Project	COUNTY FLATS, SANDFIELDS
Project number	N297
Client	HALE CONSTRUCTION LTD
Title	BLOCK 05/06 ELEVATIONS 1/2
Drawing number	A015
Scale	1 : 100 at A1
Revision	I
Status	INFORMATION
Drawn	PC
Date	30.11.21

01 E01 - Bevin Avenue Elevation
1 : 100

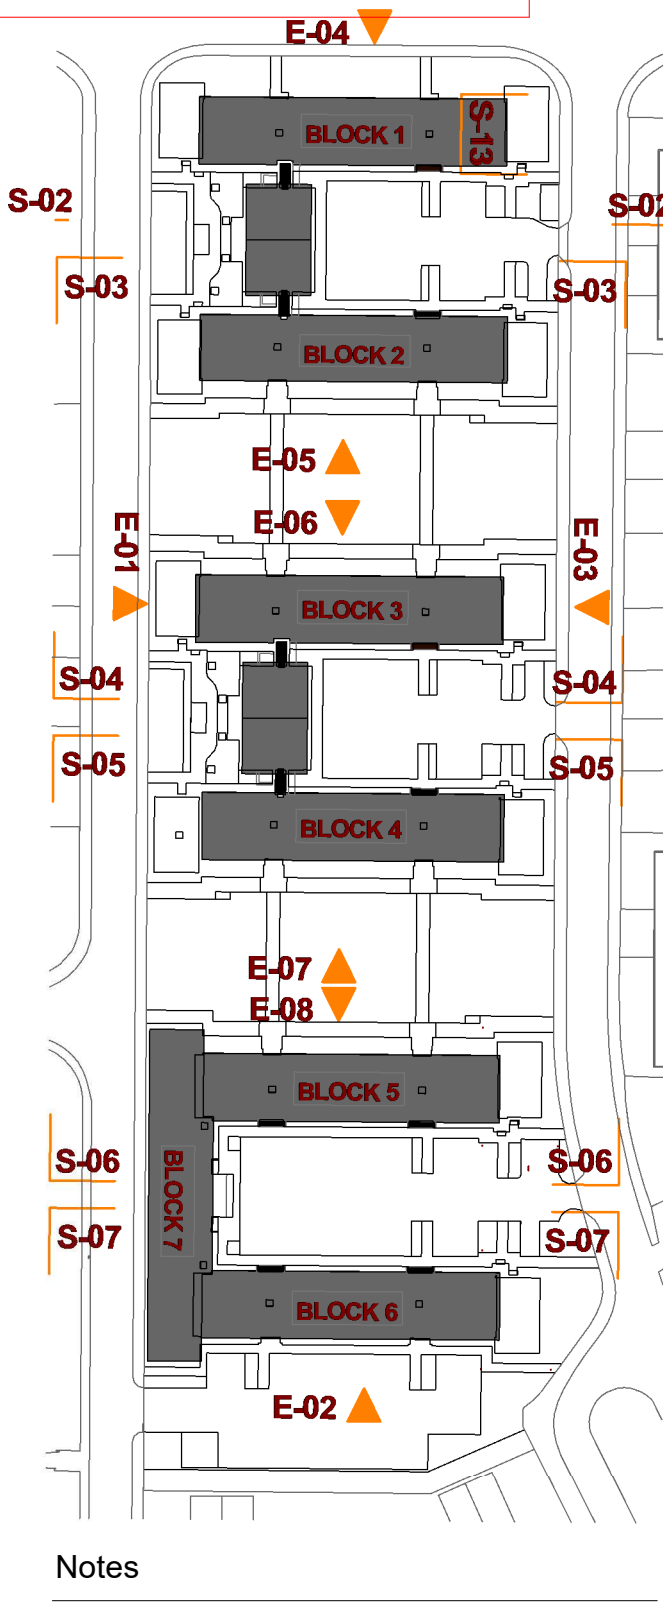
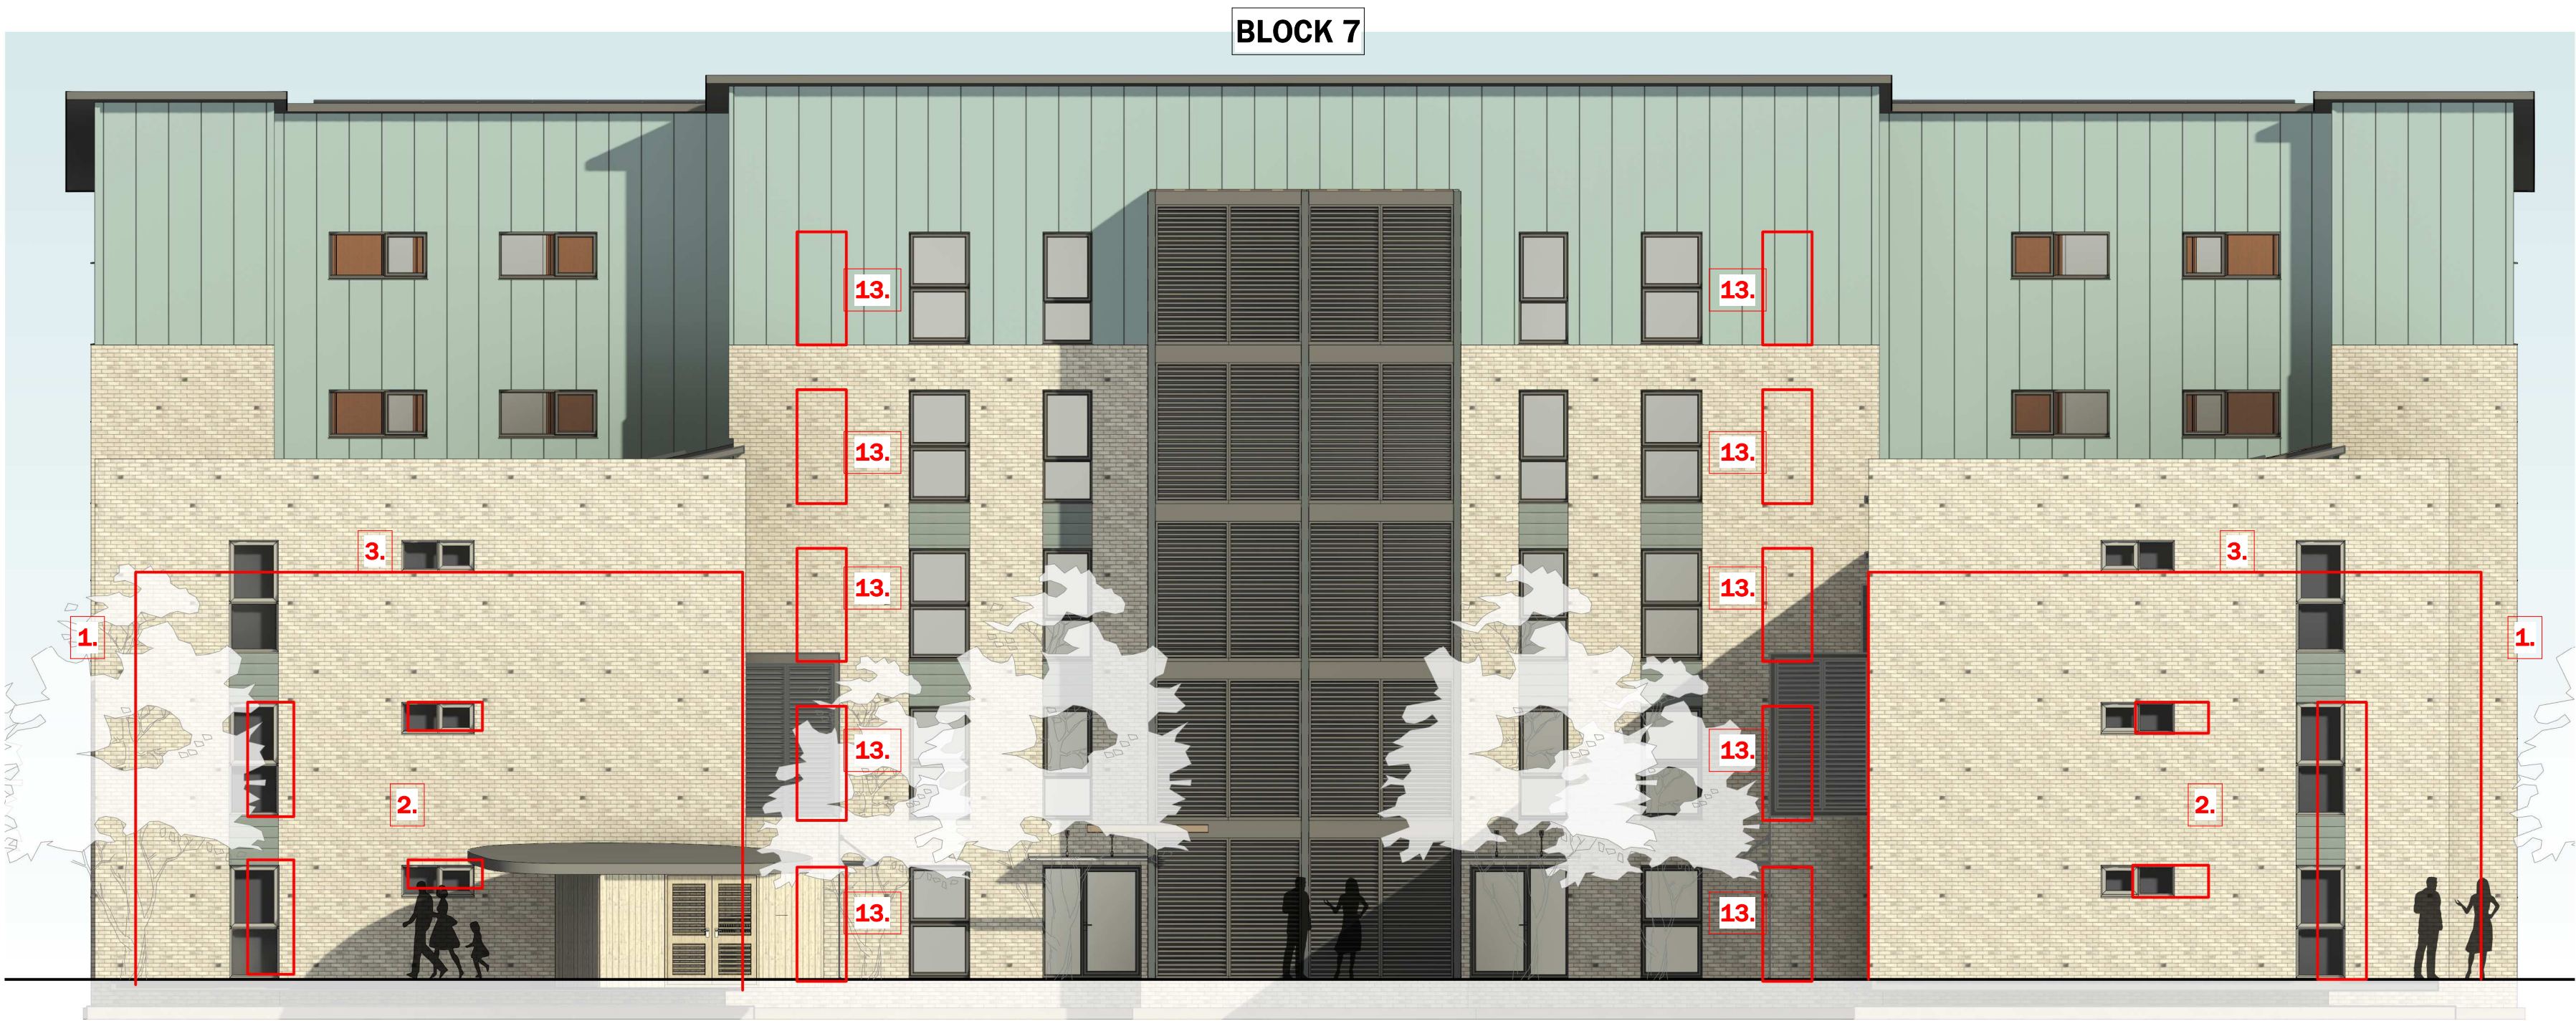
name r.k.s. to u.s.w.h.t |
- DESIGN CHANGES
1. Modular end links re-positioned slightly off existing buildings, with the party wall straightened and porch projections aligned with this wall, to ensure modular construction can be achieved off site.

2. Windows have been slightly re-positioned to the new build to suit the structural design of the modular units and the constraints of the timber frame.

3. Parapet to modular end blocks have been lowered by approx 900mm to comply with the structural wind loadings and timber frame design.
 4. Corner windows have been removed and replaced with 2no. Windows on either corner, again due to the structural and timber frame design of the blocks.

5. PV panels have been omitted from the end modular units to suit the structural and timber frame design of the blocks.
 6. Ground floor Juliet balcony added to existing flats to provide better security whilst ensuring the open areas remain as communal spaces.

7. Air source heat pump external louvre enclosure amended to be single storey over entrance canopy to end link blocks.
 8. External air source louvered enclosure handed to provide internal riser/access requirements for maintenance.

9. Buggy/cycle store added to block 6 and 7 parking courtyards.
 10. Bin stores slightly re-positioned to suit existing drainage runs, with bin store near block 6 amended in size to suit located of bedroom window.

11. Footpaths amended to be Tarmac.
 12. Windows in communal area to the linked blocks made narrower to ensure 1.8m fire separation distance to existing windows is achieved to comply with building regulations.

13. 1no. window in block 7 communal area either side of stairwell removed to ensure 1.8m fire separation distance to existing windows is achieved to comply with building regulations.
